Georgetown Charter Township

Planning Commission Meeting Agenda

SITE PLAN
WW GREENHOUSES
4044 CHICAGO DR.

GRADING + SOIL EROSION CONTROL PLAN
6555 CENTER INDUSTRIAL DRIVE

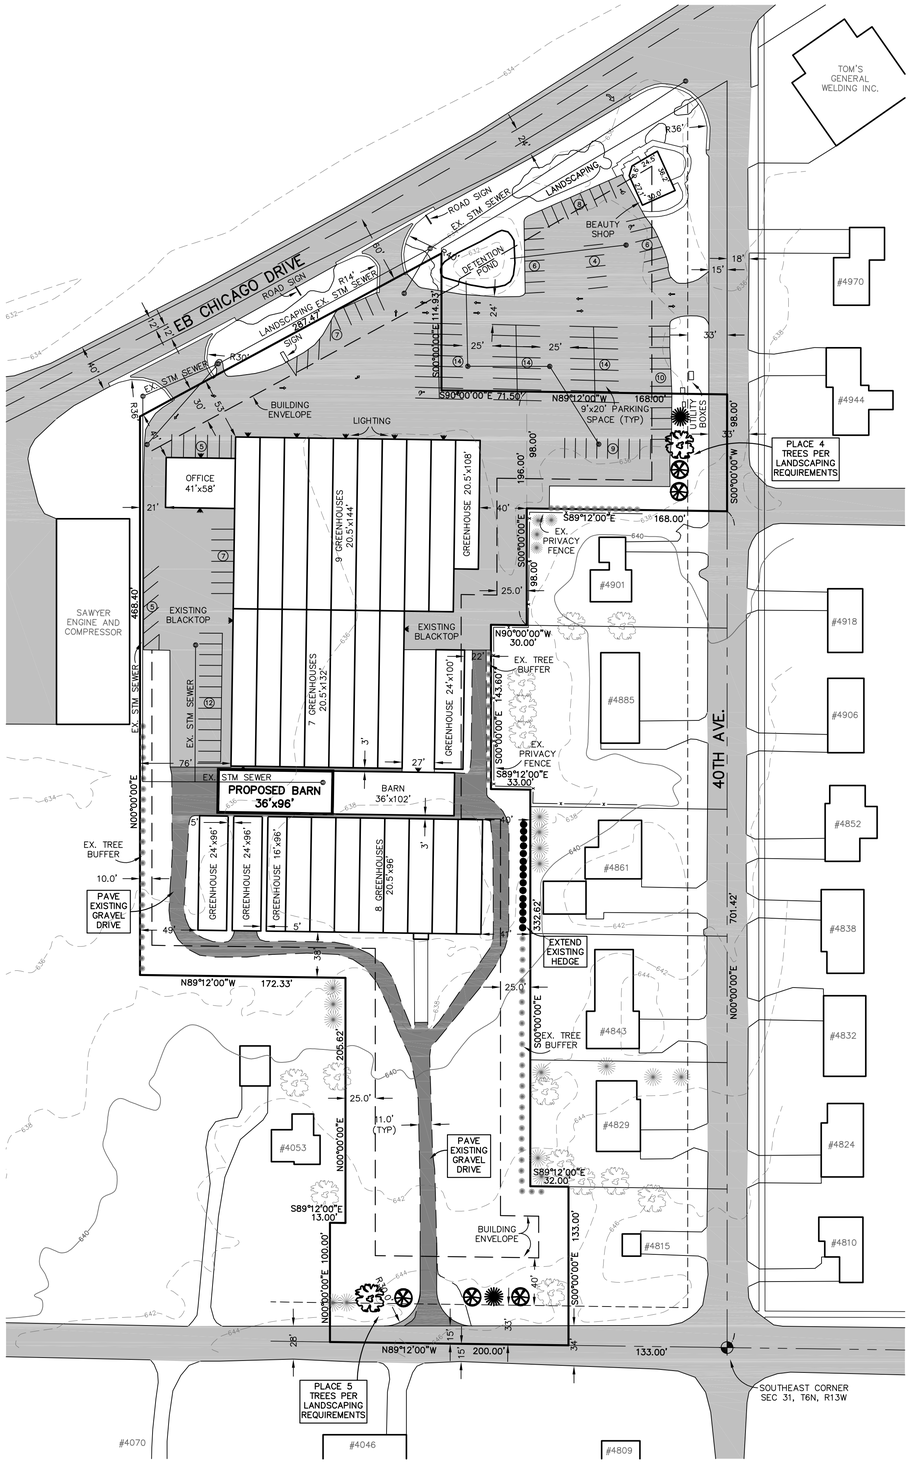
1) The front yard setback is required to be 30 feet from the property line. Chapter 24 footnote l states that the required front yard setback (30 feet) shall be landscaped and not used for parking or drives. L**andscaping and landscaping calculations along Chicago Dr. and 40th Ave. were provided.**
2) The side yard setbacks are 10 and 15; however, the Planning Commission will determine if the requirements are met in Sec. 26.3(D) for a greenbelt for a parking area adjacent to a residential district. The adjacent property to the east and south is all LDR and the 25 foot greenbelt is required. **Landscaping calculations were provided.**
3) The rear yard meets the requirement to be 40 feet. **Landscaping or the greenbelt along New Holland was provided.**
4) **The building at the corner of Chicago Dr. and 40th Ave. is not included in this proposal.**

As per the plan, landscaping and greenbelt calculations were provided for along Chicago Dr., 40th Ave. and New Holland. Some additional landscaping is proposed; however, the plan shows that much landscaping already exists. The applicant is asking for the Planning Commission to determine that the existing landscaping meets the ordinance requirements for streetscape and for greenbelts.

The Planning Commission should determine if the landscaping and greenbelts as proposed (with the addition of landscaping as noted on the plan and with the existing landscaping and greenbelt) meets the ordinance requirements for streetscape and greenbelts.

b. Lot coverage was provided and meets ordinance requirements since a variance was granted in 1988.

c. The driveway is noted to be paved.

e. Sign and lighting details were provided. They currently exist and no changes are proposed.

f. As per the parking calculations, 74 spaces are required and 61 spaces are provided on the site and an additional 60 are shared from the neighboring site.

h. **A Storm Water Drain permit (written approval) from the Ottawa County Water Resources Commissioner's office will be required at the time a Zoning Compliance/building permit application is submitted**.

drained so as to dispose of all surface water. **Variance granted for northern section only. A hard surface for the southern driveway is noted on the plan to be provided.**

(8) All lighting shall be shielded from adjacent residential areas. **Lighting is noted on the plan and appears to meet this standard.**

1. The parcels shall be combined (P.P. #70-14-31-400-051and 70-14-31-400-041) at the time a Zoning Compliance/Building Permit application is submitted. To combine the parcels, both parcels must be in the same name and a letter signed by all owners must be submitted to the assessor requesting the combination.
2. A Storm Water Drain permit (written approval) from the Ottawa County Water Resources Commissioner's office shall be submitted at the time a Zoning Compliance/Building Permit application is submitted.

SITE LAYOUT + UTILITY PLAN
6555 CENTER INDUSTRIAL DRIVE

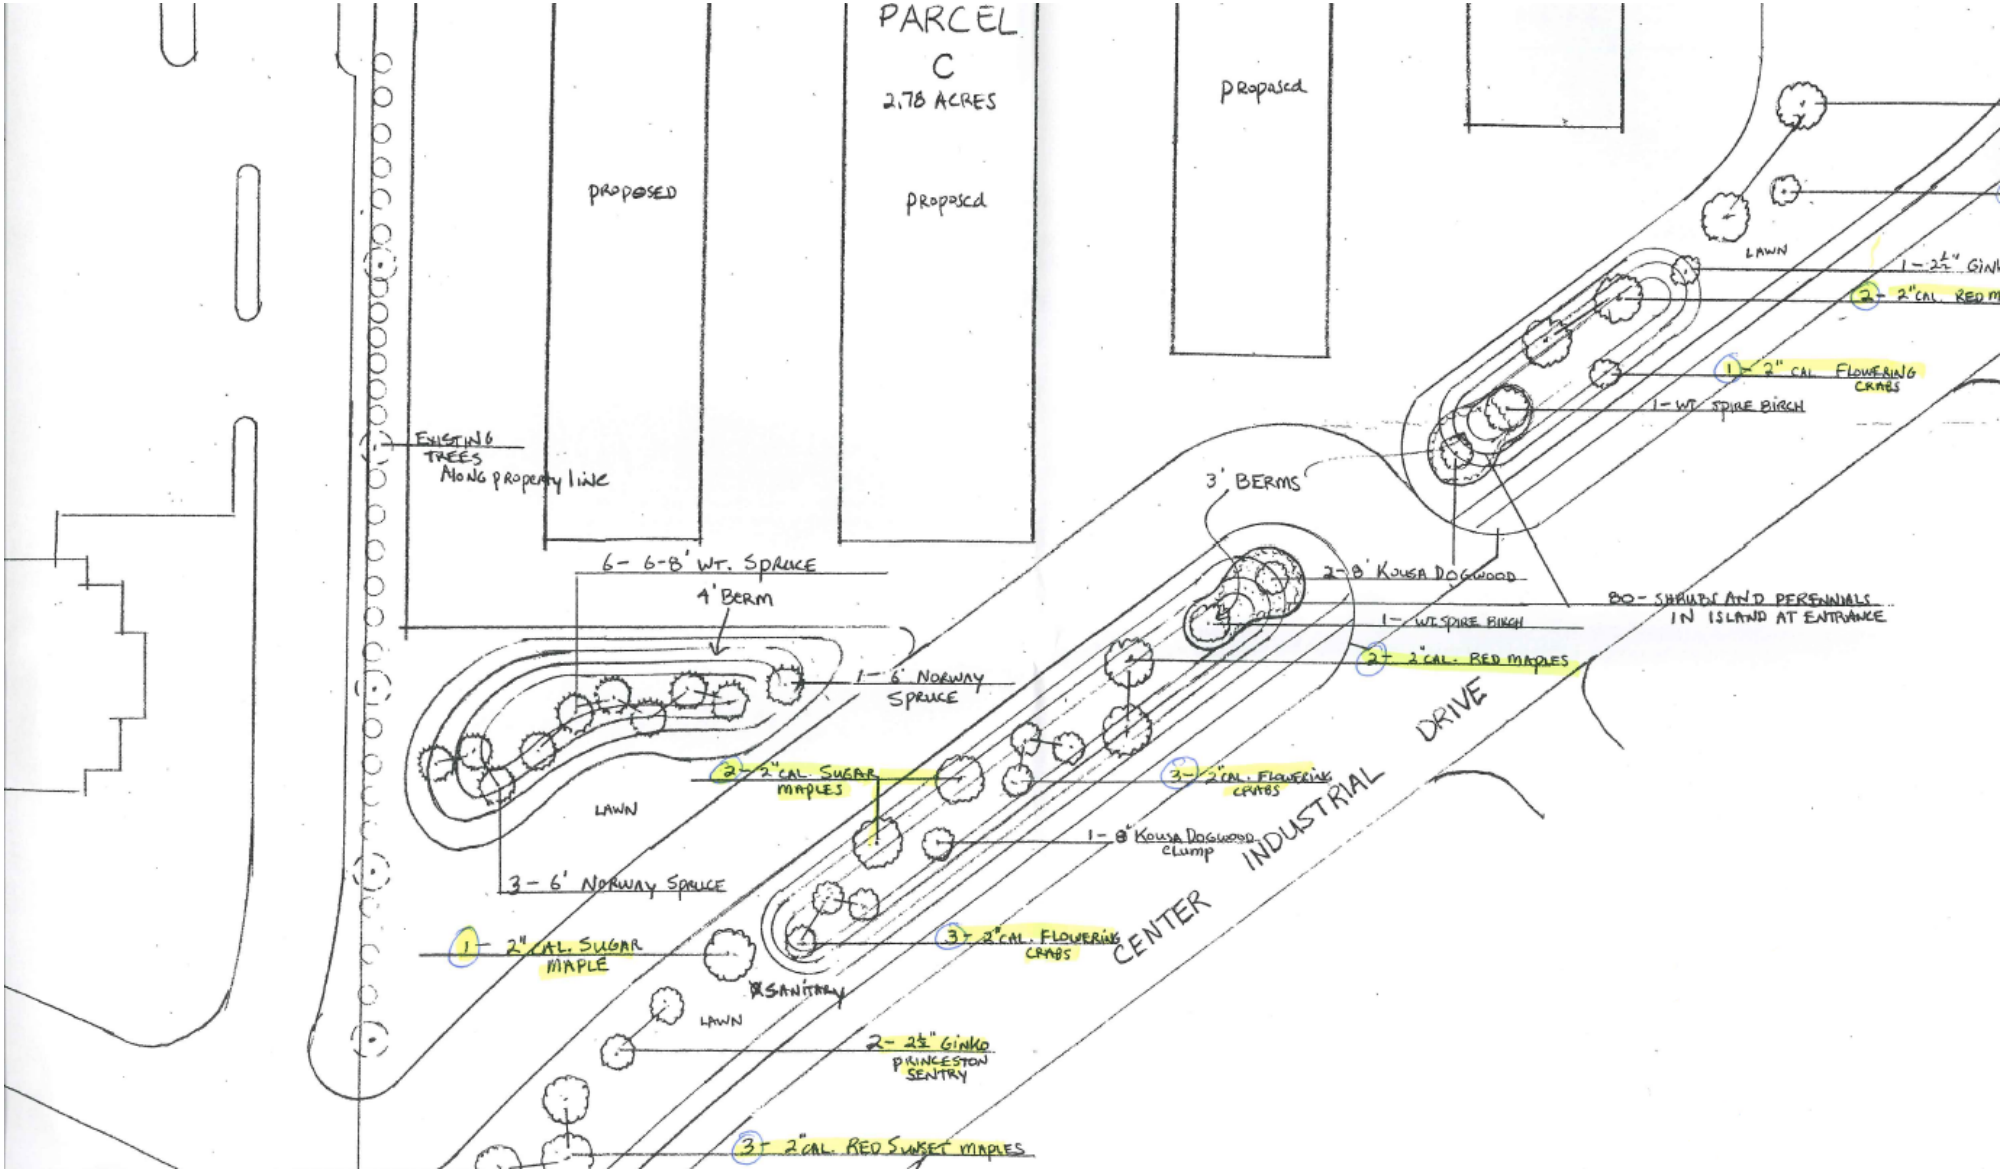
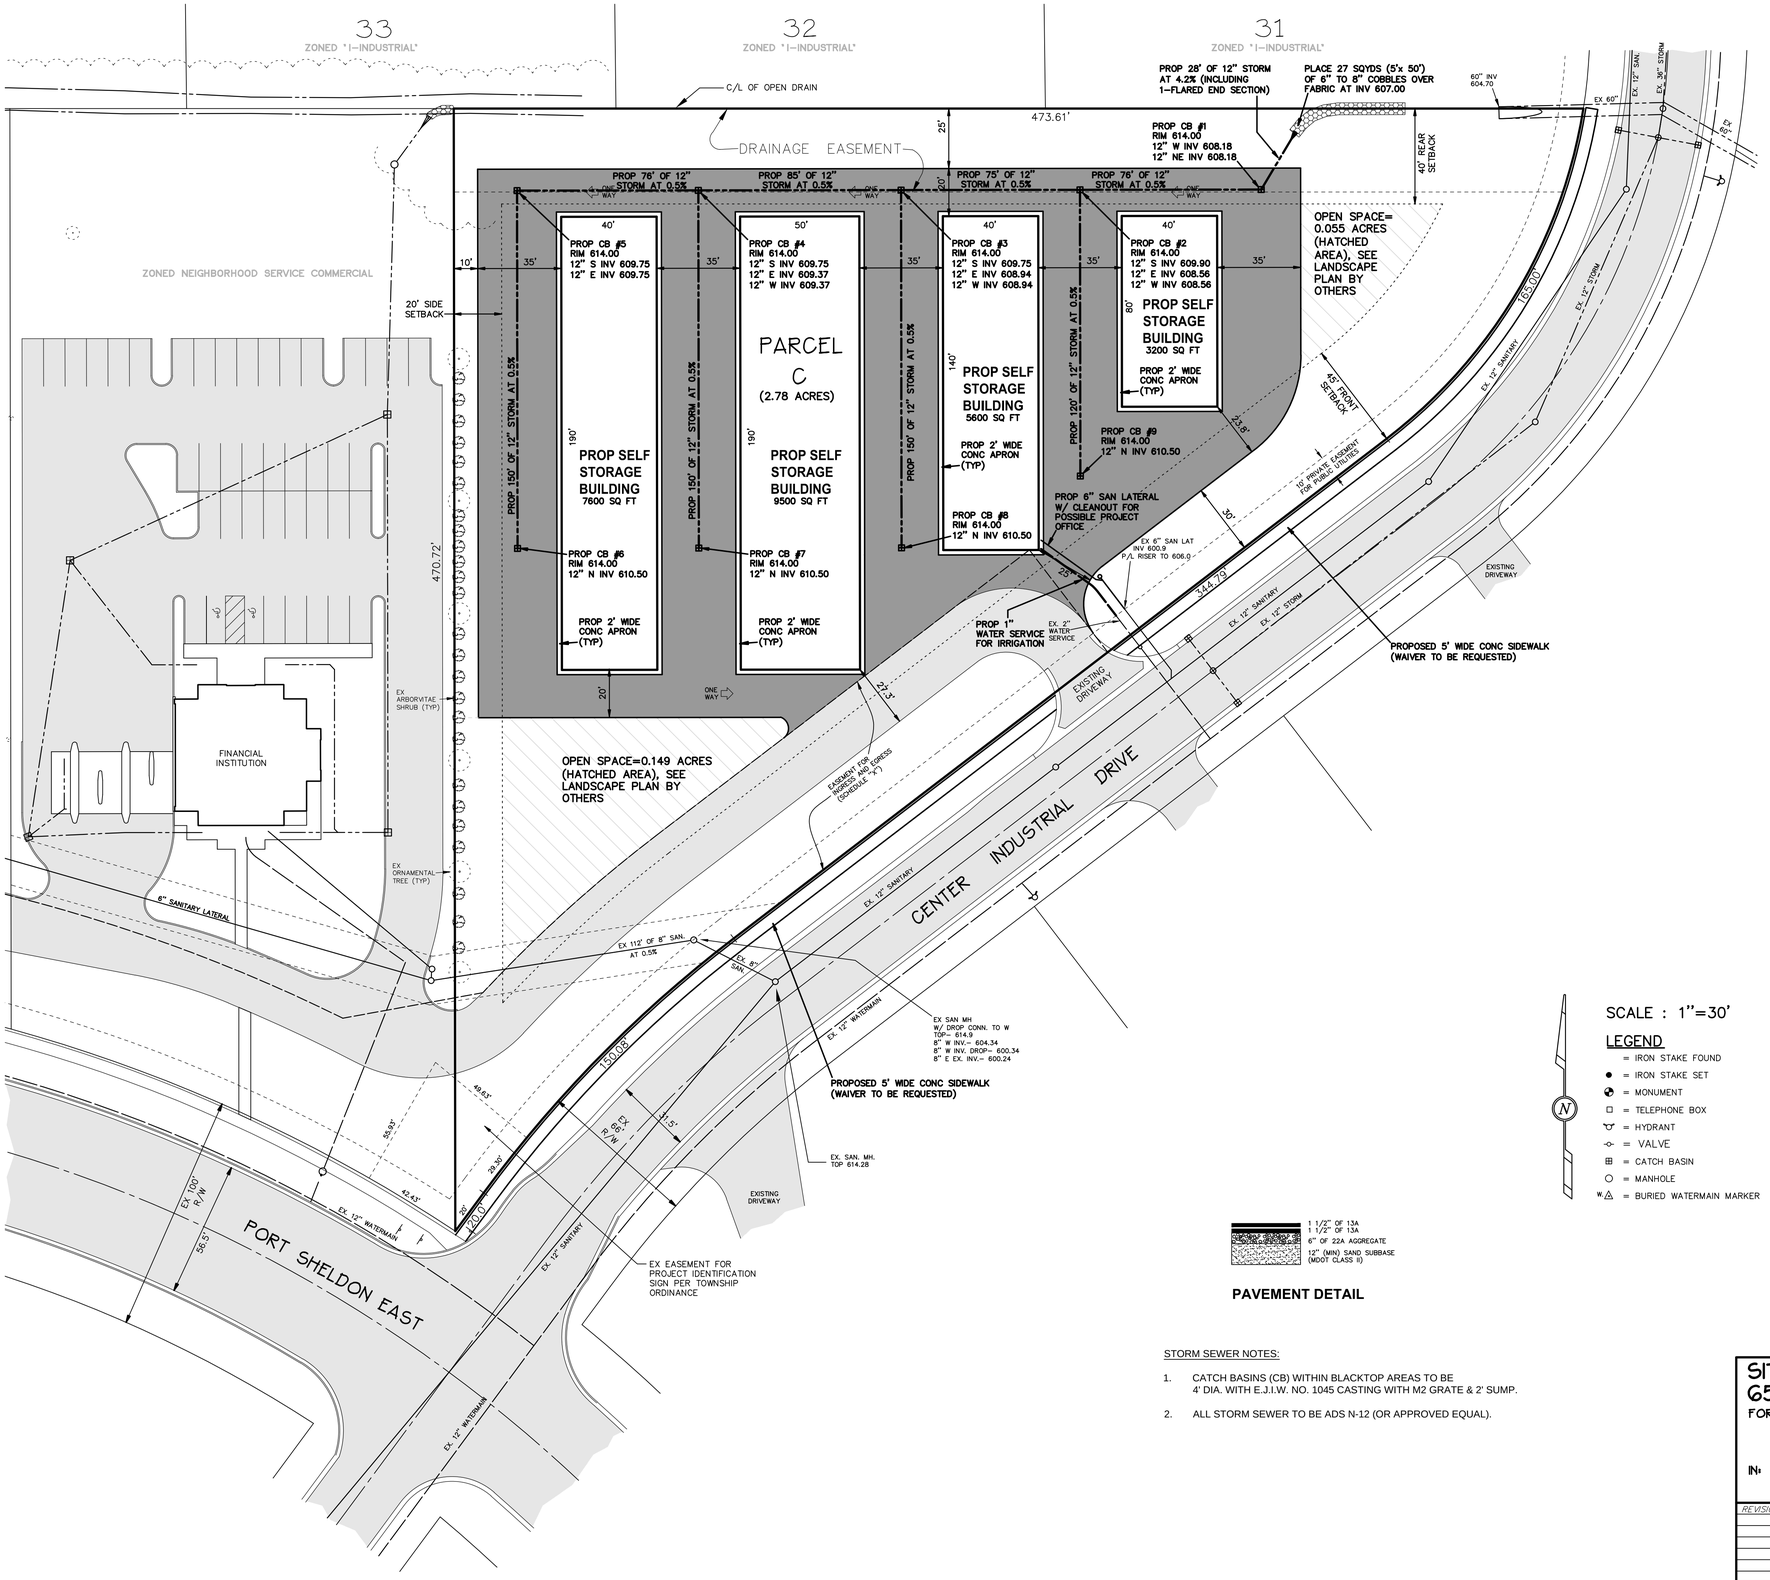
5. **Open Space.** A total of 0.21 acres of open space is proposed, which is 7.5%, less than the 20% that is required**.** Ten evergreens are proposed to be planted on a berm in the open space. **The determination is that the proposal _____ (does or does not) meet the ordinance requirements for open space.**

The parcel is 2.78 acres and 20% is 0.56 acres. The plan shows 0.06 acres of open space at the northeast corner and 0.15 acres at the south corner for a total of 0.21 acres which is 7.5%, less than what is required. Even if the open space is not set apart for "active" usability, it could be set apart for "passive" usability such as for detailed and extensive landscaping. Nothing has been provided indicating what will be in these areas. Landscaping is provided in the open space (10 evergreens). The Planning Commission and Township Board will determine if this proposal meets the ordinance.

None are provided within the site and a waiver is requested from the Board to eliminate the requirement of sidewalks along Center Industrial Dr. The Planning Commission and Township Board will have to determine if the amount is acceptable.

Styles NOT PROVIDED but a note on the plan indicates that lighting poles will be a maximum of 25 feet tall and will be downward directing.

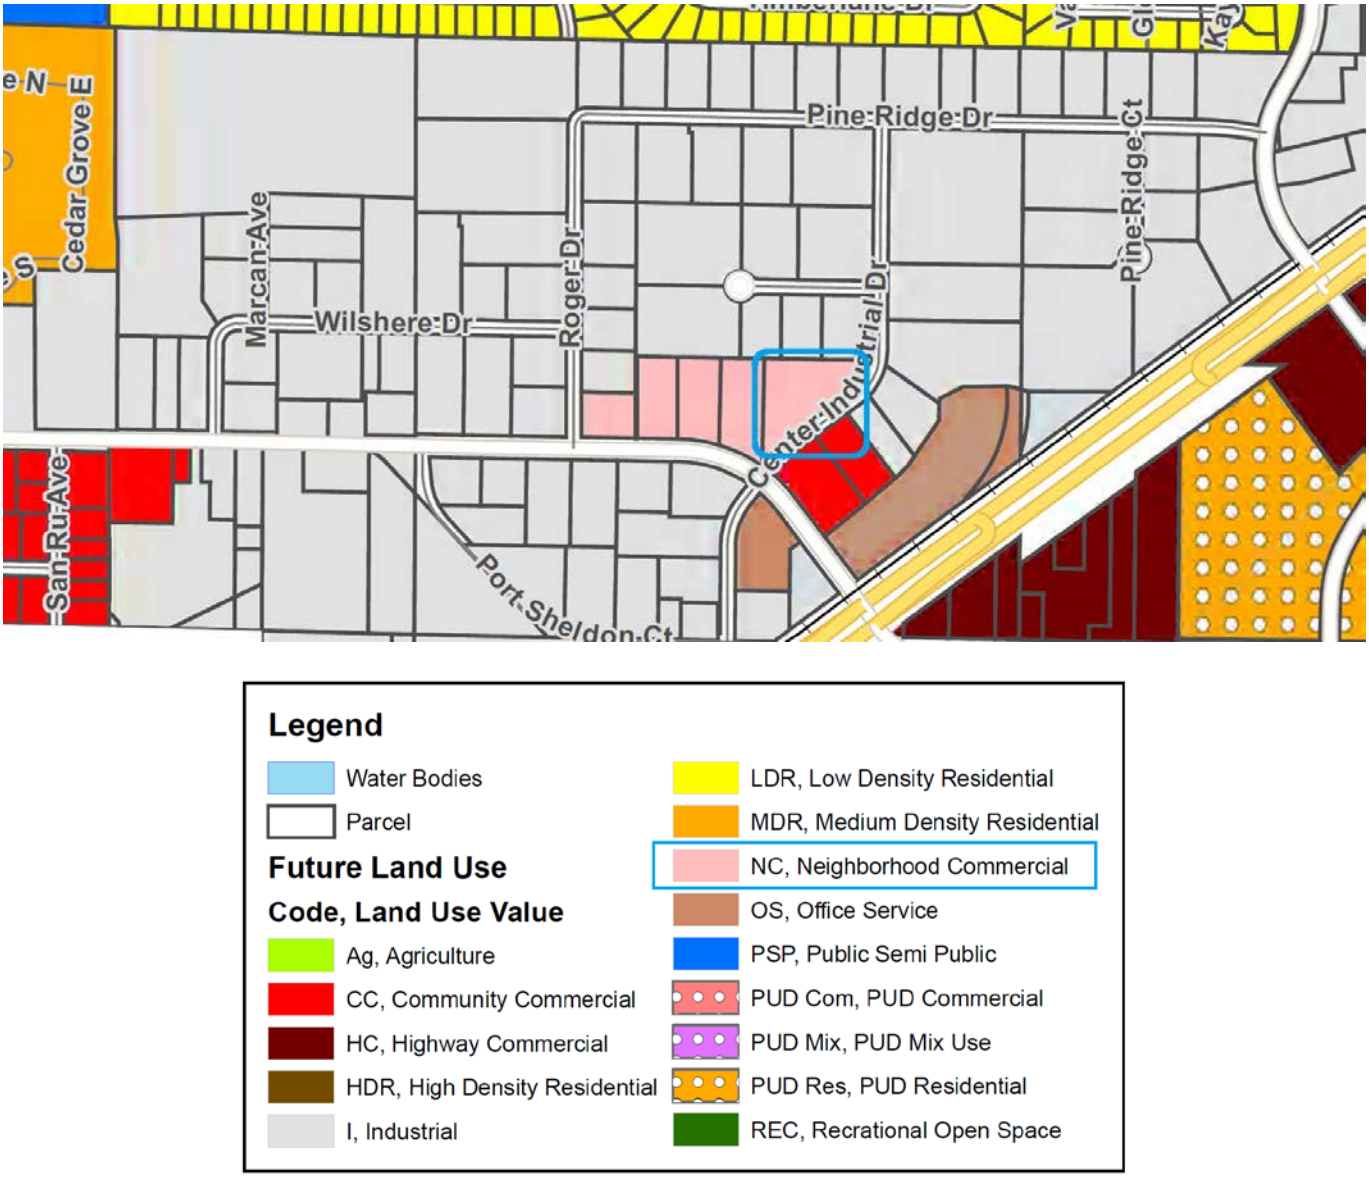
The Planning Commission will determine if this standard is met. The Future Land Use Map designates the parcel to be NC (Neighborhood Commercial). However, the site is adjacent to the Industrial designation and page 35 of the Master Plan states that the lines separating use categories are NOT to be considered as defined line and are not necessarily parcel specific.

Based on the issues, goals and policies presented, and on consideration of potential future population growth in the Township, a map titled "Georgetown Township Future Land Use Map" dated November 23, 2015, depicting the desired future development pattern in the Township was prepared and may be viewed at the Georgetown Township Office or online. **It is noted that lines separating land use categories are NOT to be considered to be defined lines and the lines are not necessarily parcel specific**.
